INFO ONLY. SEE PROPOSED AMENDMENT 74: PLA-3209 6/16/89.

3/4.4 REACTOR COOLANT SYSTEM

3/4.4.1 RECIRCULATION SYSTEM

Figure 3.4.1.1.1-1
THERMAL POWER/CORE FLOW LIMITATIONS

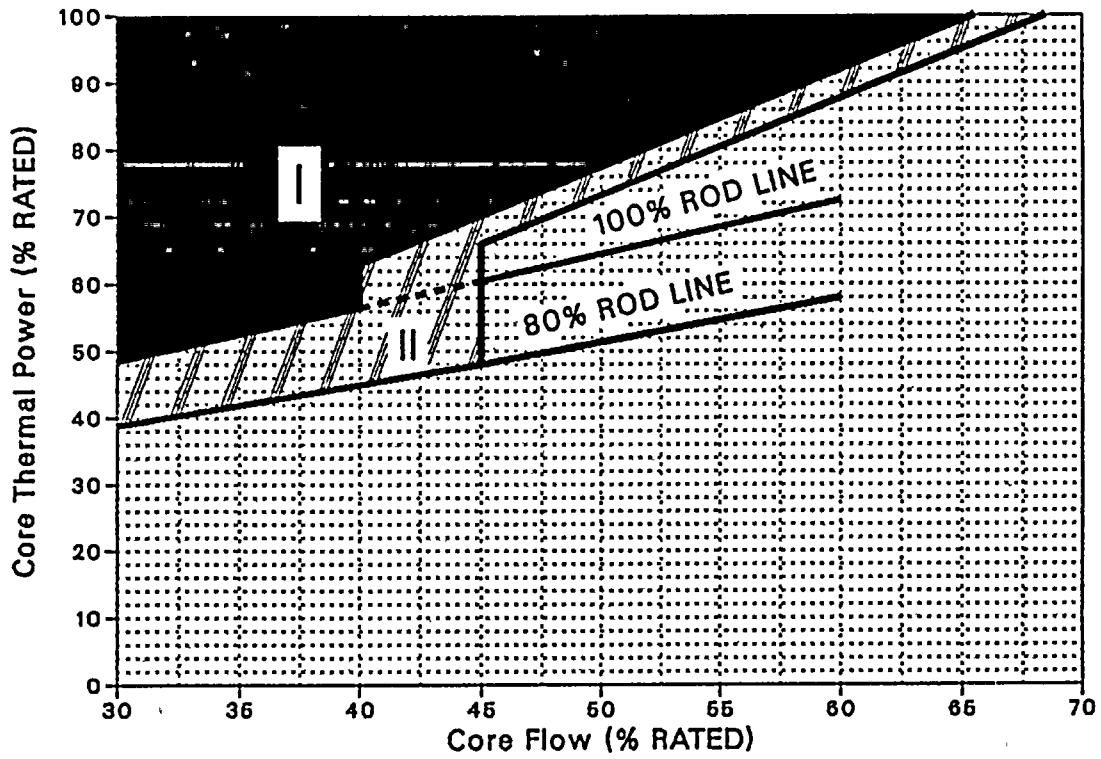
REPLACE WITH REVISED
FIGURE 3.4.1.1.1-1

Figure 3.4.1.1.1-1
THERMAL POWER RESTRICTIONS
